CITY OF ALAMO HEIGHTS

Request for Proposal (RFP)
for
General Construction for the Alamo Heights Pool
Pocket Park

Addendum 1

Addendum 3

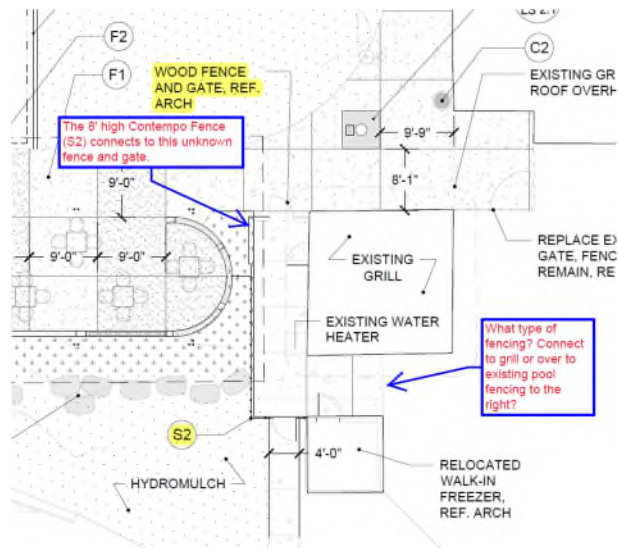
Q4. C1.1 "E. Refrigerator to be relocated (coordinate with cooler manufacturer)." S2.01 does not show a new concrete slab at the new location. If one is required, please provide details.

A4. Pending manufacturer recommendations, but the new slab does not need to be specifically engineered. A 4" slab at 2,500lbs capacity would suffice with 2" rigid insulation below slab for insulation.

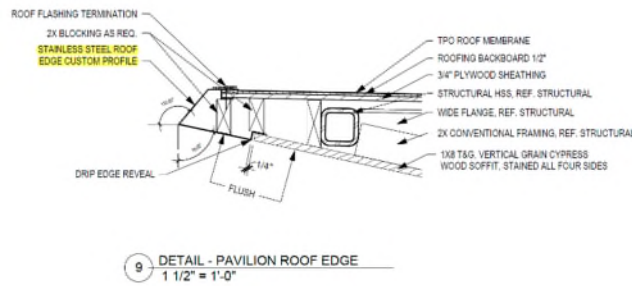
- Q7. Fencing: LS1.1—The fencing and gate connecting to the relocated walk-in freezer is noted as S2—8' high Contempo fencing with a 3' gate. The Contempo fencing connects to an unknown fence and gate. Should this match the capped & painted privacy fence that will be installed on the other side of the existing grill? What type of fencing will enclose the freezer on the east side of the concrete area? Or should it connect from the side of the freezer over to the existing pool fence to give a larger storage area?**

- A7.** The unknown fencing will closely match the 2x2 wood screen installed at the pavilion but it will be painted at this location instead of a stain. 2x2 wood fence shall be installed at 8' A.F.F. with 2" gaps between each 2x2 member. Horizontal painted steel pipes (3) will support the 2x2 fence along with vertical steel pipes at regular intervals. At this time, no additional fencing (to the east) is needed to enclose the walk-in as one already exists and will remain.
- Q8. LP1.1 – The brick planters around the trees near the front of the building will be removed. The dirt level is much higher than the surrounding concrete. The planting plan shows the millstones around approximately 2 sides and planting under the trees. Are we to slope the dirt down to concrete level? We are concerned tree roots could be exposed and possible erosion.**

- A8.** The plans are showing walls to remain at the 2 sides of each tree well where the existing sidewalk is staying in the same location. The other two sides of each tree will have additional planting space for what is there today, and the soil should be sloped to meet grade.
